# NATIONAL WEATHER SERVICE

## Engineering Handbook

### MODIFICATION INDEX - RAMOS

RAMOS MODIFICATION NO. 1  
(For Electronics Technicians)

FIGURE 2a

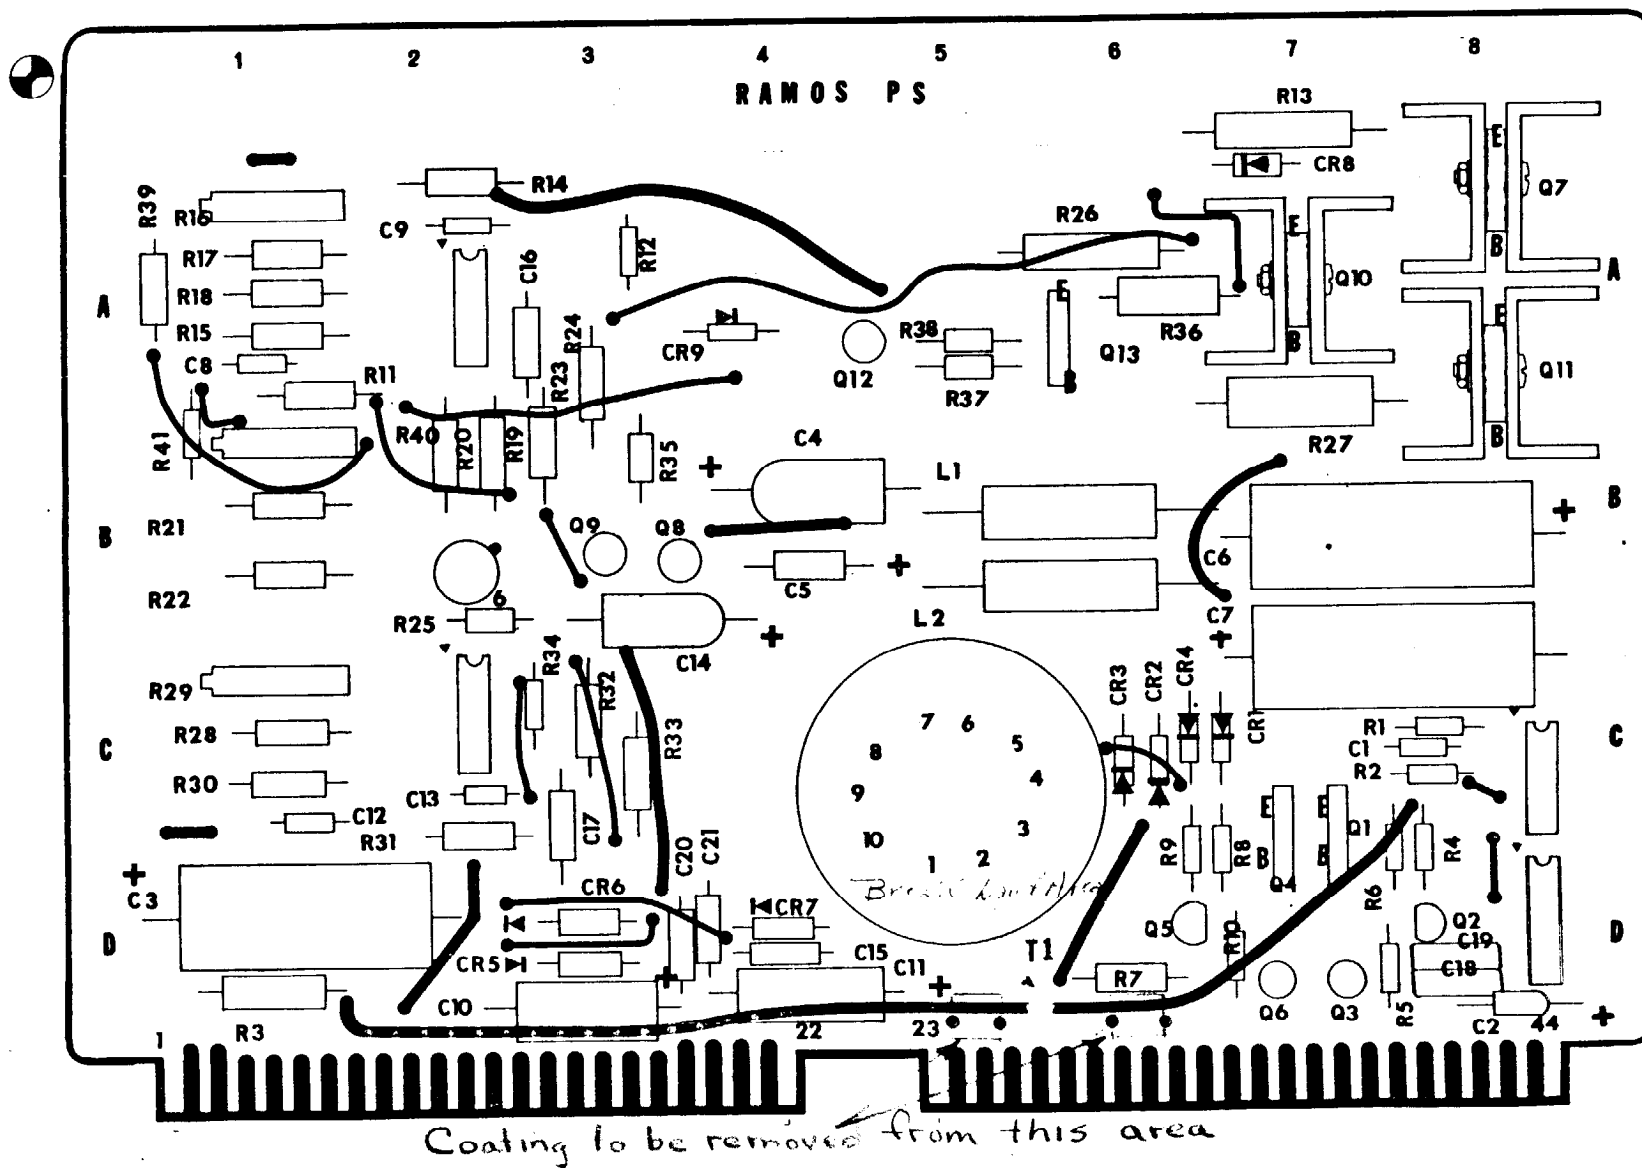
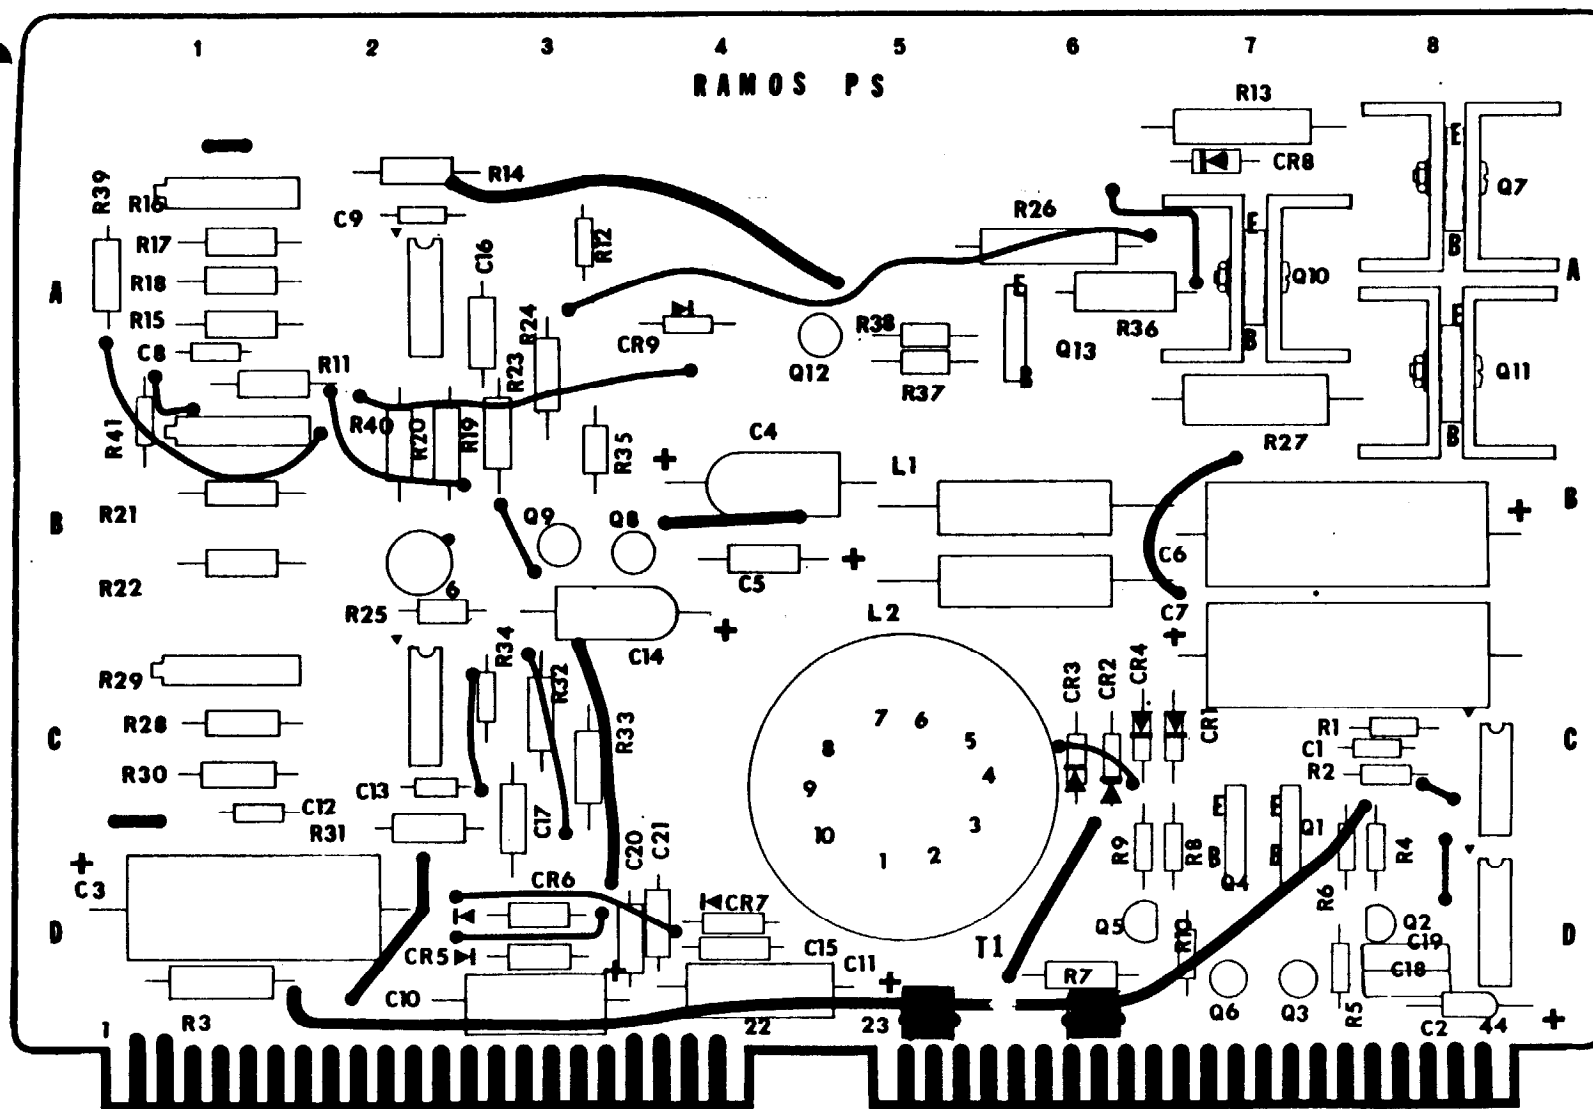
1. Turn off the power to the BEA and remove the Power Supply Module 1A1A1. Place the printed circuit board on a suitable working surface.
2. Using the fuse and fuse clips as a guide, mark and drill four (4) .0625 (1/16) inch diameter holes as shown on the printed circuit board artwork. See Figure 1a.
3. Remove the protective coating from the area of the printed circuit board which will be under the fuse clips. See Figure 2a.
4. Remove approximately 1/4" of the land between the fuse clip mounting area as shown on the printed circuit board artwork. See Figure 2a.

5. Press the fuse clips through the drilled holes on the printed circuit board and bend over the tabs on the back of the board. See Figure 1 b.
6. Solder the fuse clips to the land area. See Figure 2b.
7. Install the 1-amp. fuse taken from the Replacement Item Kit.
8. Return the Power Supply Module back to its proper location in the BEA of the RAMOS as this completes the modification.

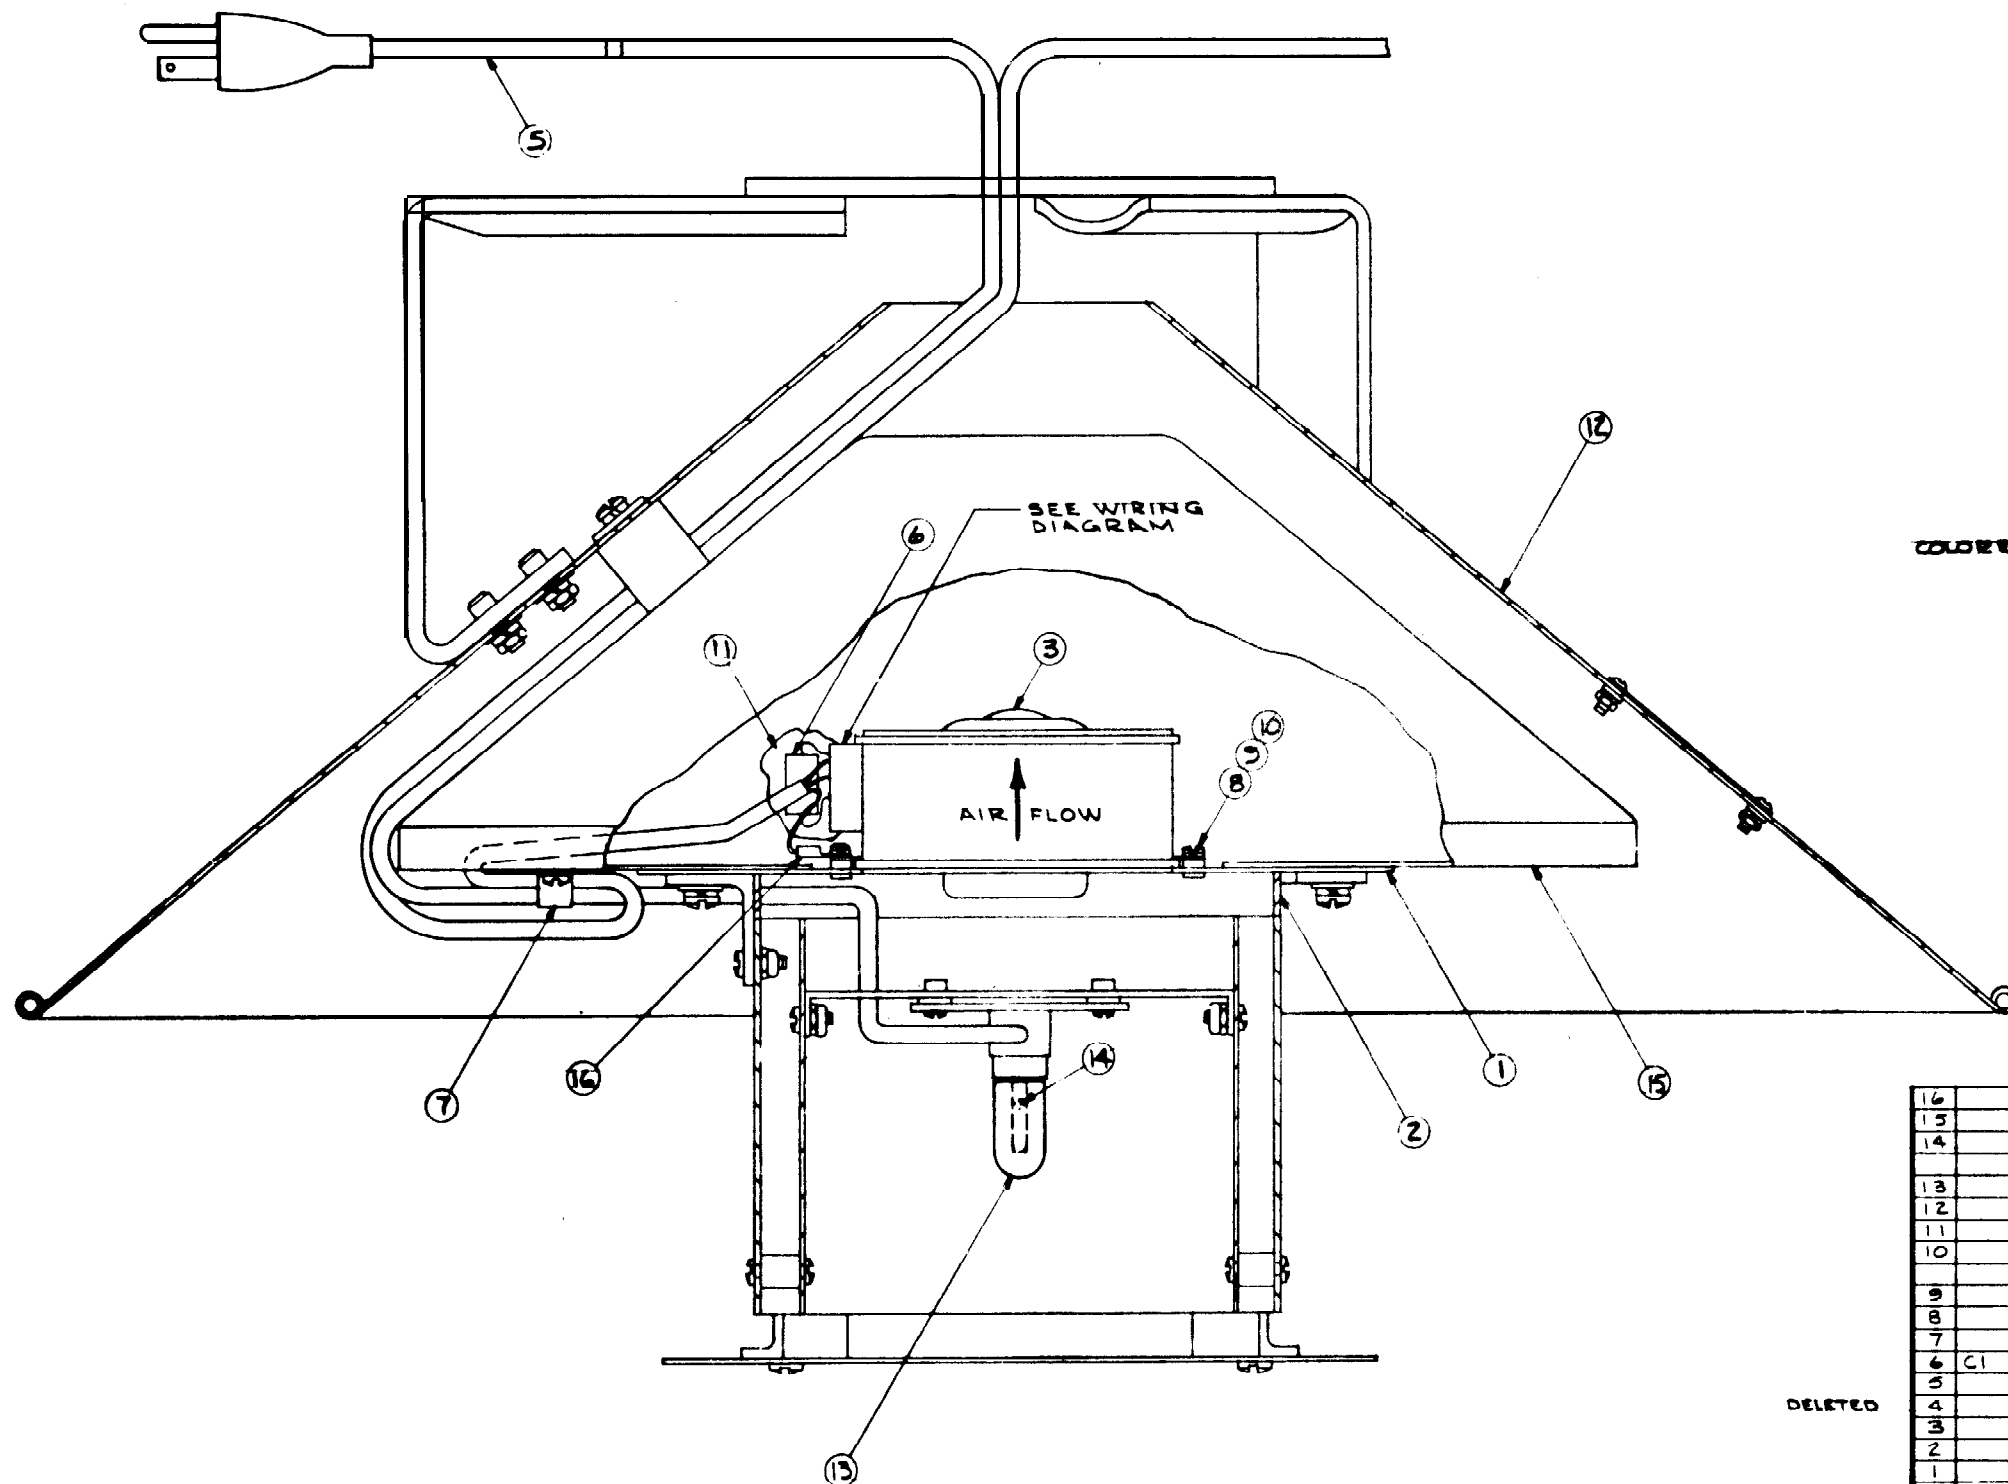
7. Refer to Drawing S010-F3T4-DR005. Adhere the large template required to cut the hole in the bottom of the inner hat assembly in the manner suggested. That is the three crosses over the three mounting screw-holes. Release the adhesive portion of the template approximately 2 inches from top. Line up two holes with template. Slowly remove template backing and ascertain that 3rd hole is lined up before removing backing completely. It may be necessary to repeat this operation a few times before the template is positioned properly.

9. Refer to Drawing SO10-F3T4-DR005. Adhere the small template required to enlarge the hole in the top of the inner hat assembly. Using the cutting snips enlarge the hole to the size as indicated. Remove any remaining portion of the template from the top of the inner hat assembly.

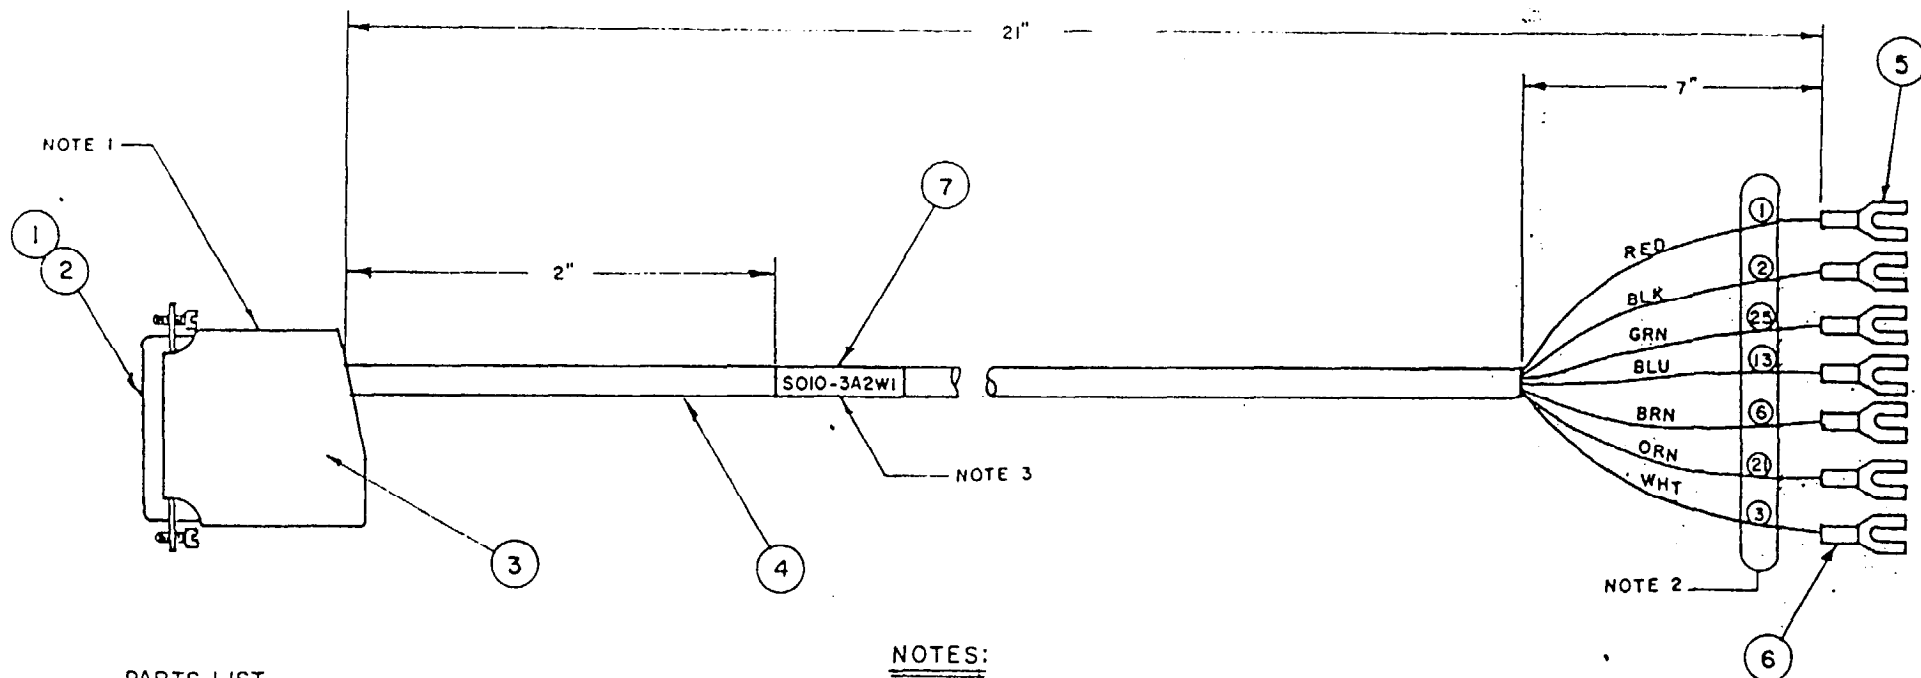
On drawing #S010-3A2W1-SD001, at the end of note 1, add the following: "and pin 10 to pin 23".

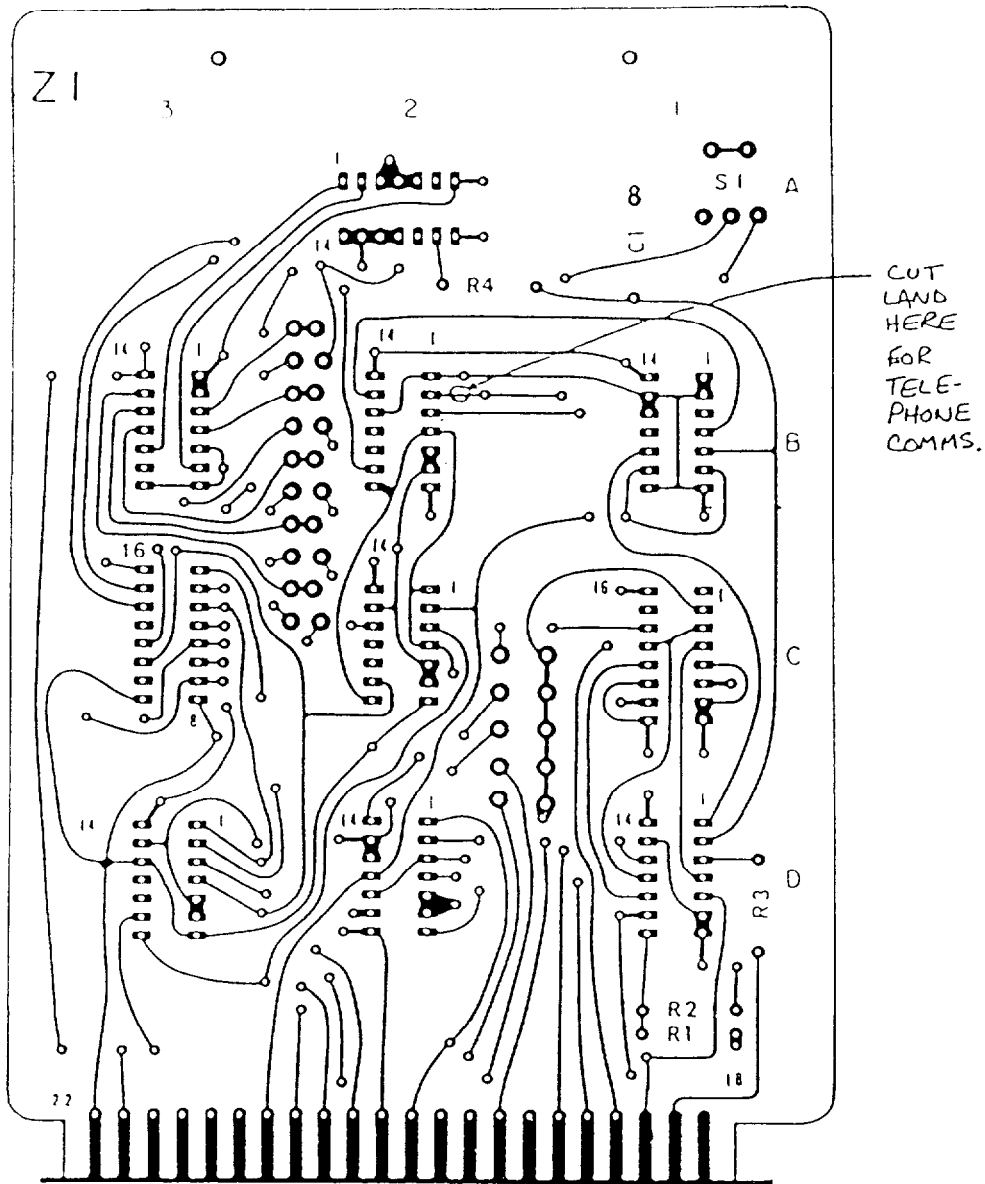
1. Modify the station spare PWB S010-1A1A4 in the following manner. Obtain a very sharp knife -- "Exacto" or equal. Remove a portion of the land using the attached drawing (enlarged back view 1A1A4) as your guide. This will open the output of Pin #2 of the integrated circuit in location 2-B. Make the cut as close to pin #2 as possible, leaving enough land material, so it can be restored to original condition if it should need to be returned to NRC.
2. Proceed to RAMOS/T Site and exchange boards.

Figure 2

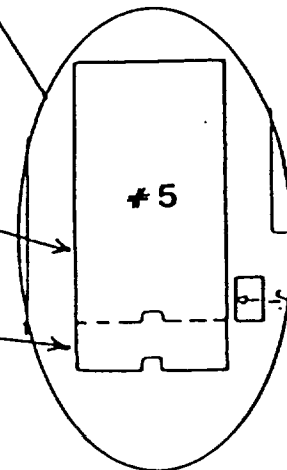
8. If your board has 28 pin sockets, then plug in the new EPROM so that pins 1, 2, 27, and 28 of the socket are left exposed. In other words, pin 1 of the EPROM plugs into pin 3 of the socket. See Figure 2 for a guide. (If your board has 24 pin EPROM sockets, then just plug it in normally.)
